IMT (Portland International Marine Terminal)

**RE: Portland International Marine Terminal
Existing Laydown and Connecting Corridor Connection Project
Response to Staff Comments**

RE: Site Plan Application for Portland IMT, Existing Laydown and Connecting Corridor Connection
Site Plan Addendum #4

Memo To: Rick Knowland
Barbara Barhydt
From: David Margolis-Pineo
Re: Review Comments from Public Services
528 Commercial Street – International Marine Terminal

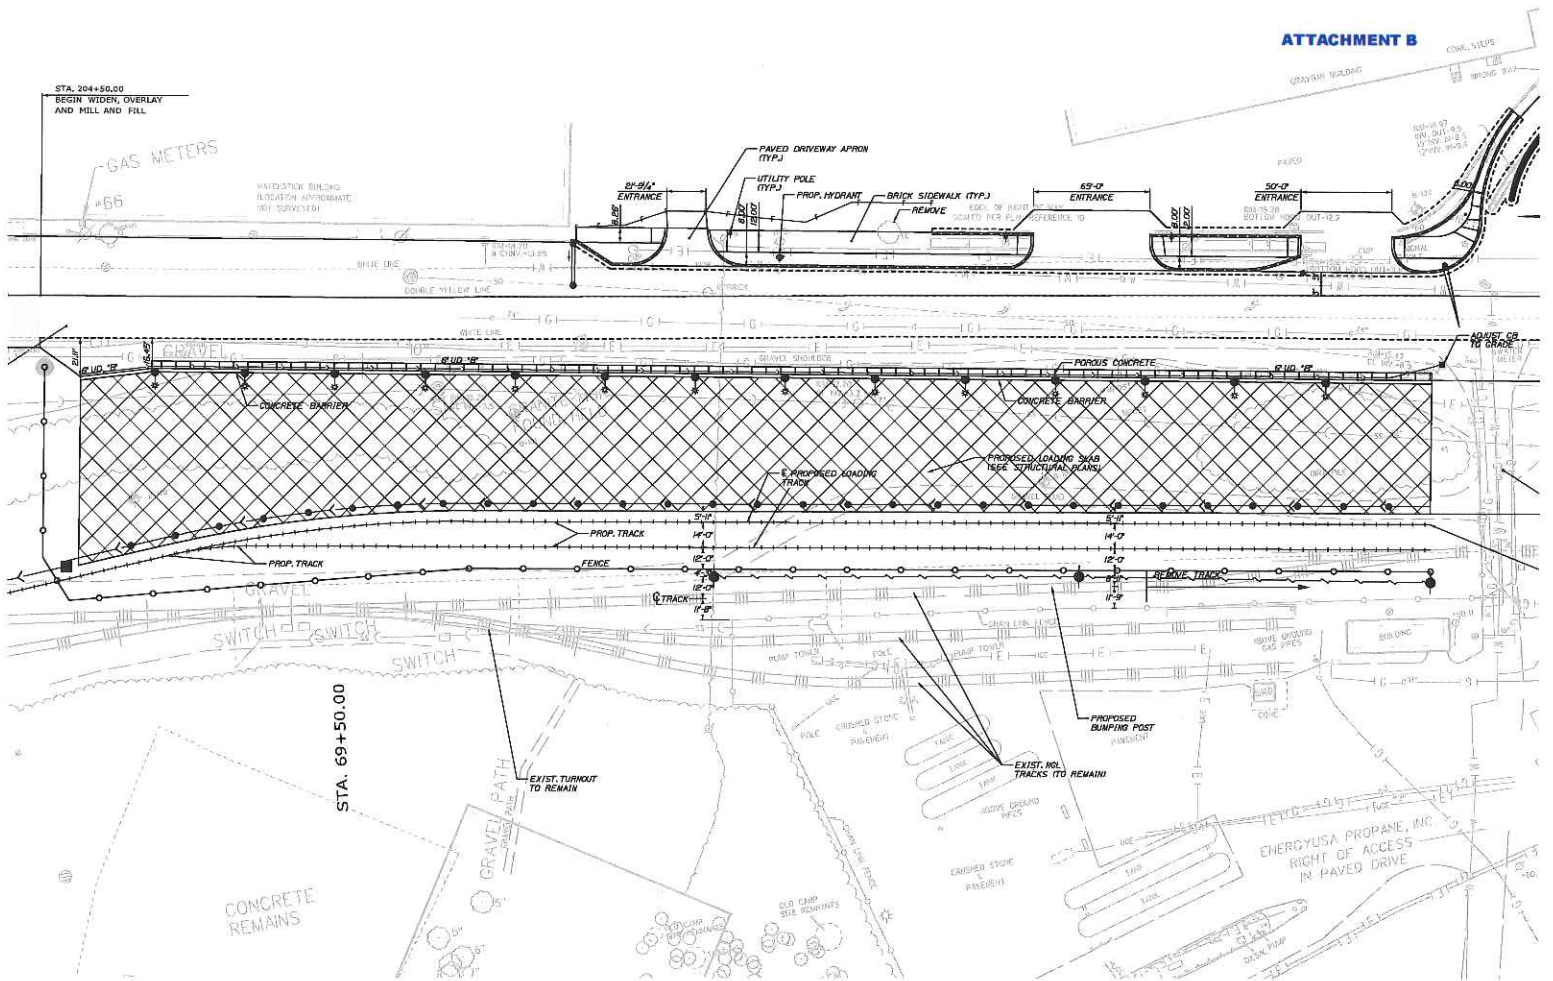
1. A four foot concrete barrier is proposed along the Commercial Street right of way adjacent to the proposed loading dock. Also proposed along this same area within the right of way are porous concrete panels. It seems apparent that snow removal will be required to allow for proposed parking and to allow drainage. Since the City cannot guaranty snow removal in a timely fashion, it is proposed that the applicant pull all infrastructure back onto the applicant's property six feet and to reach an agreement with the City to allow for snow storage in this vacated area on the applicant's property.

2. To accommodate vehicle turning movement, the applicant is proposing to pave from the road right of way well onto the applicant's property. The City agrees to maintain infrastructure within the right of way with the understanding that all proposed work within the road right of way meets City of Portland Technical Manual standards.
